FF-L-2740
INT. AMENDMENT-2
February 25, 1994
SUPERSEDING
Int. Amendment-1
February 9, 1994

INTERIM AMENDMENT
TO
FEDERAL SPECIFICATION
LOCKS, COMBINATION

FIGURE 1
Schematic arrangement of lock case holes.

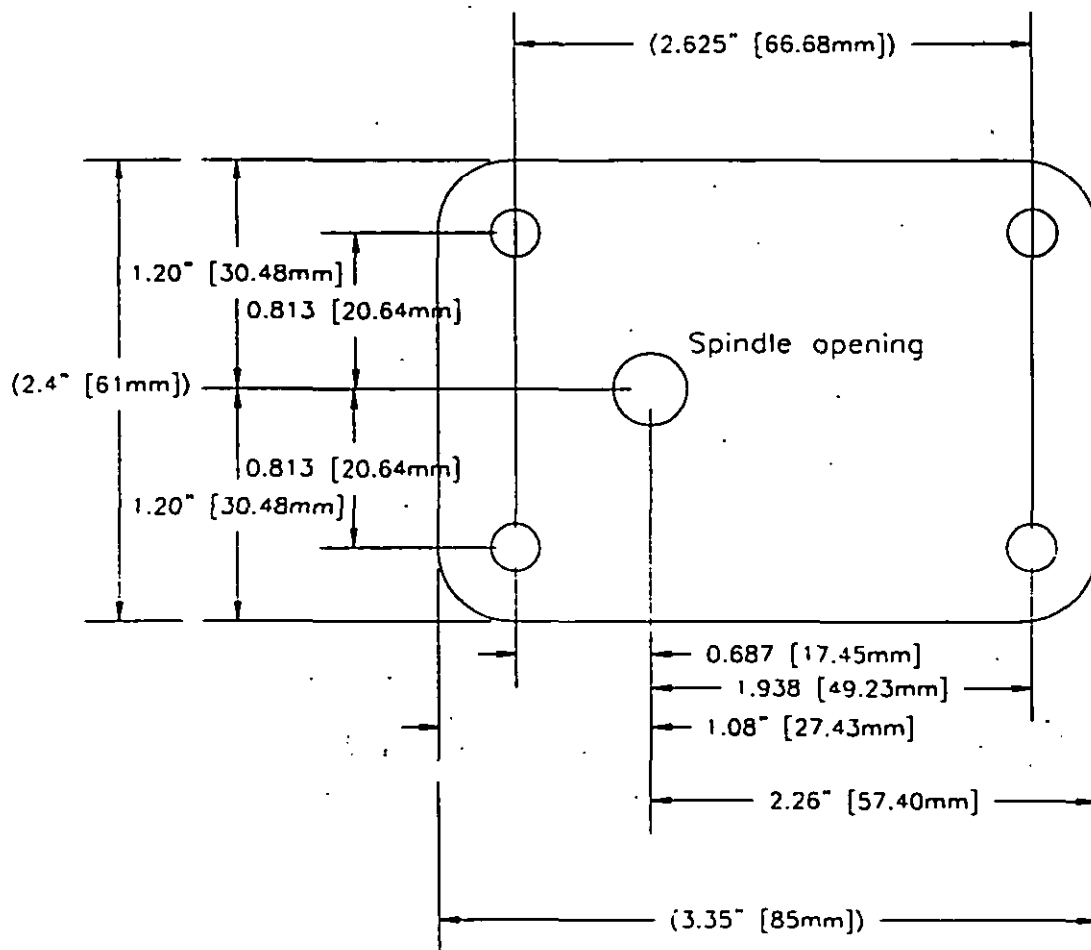
Delete Figure 1 and substitute the attached Figure 1.

Figure 2a - Case and Bolt Strength Test

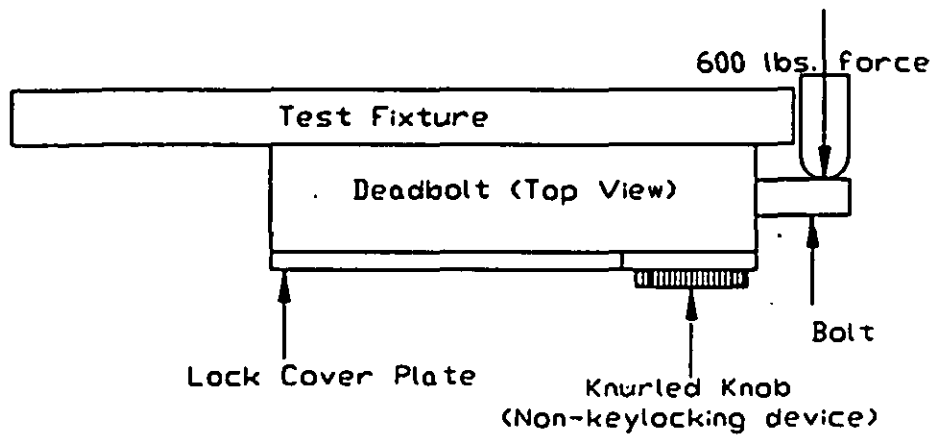
Add new Figures 2a, 3a and 4.
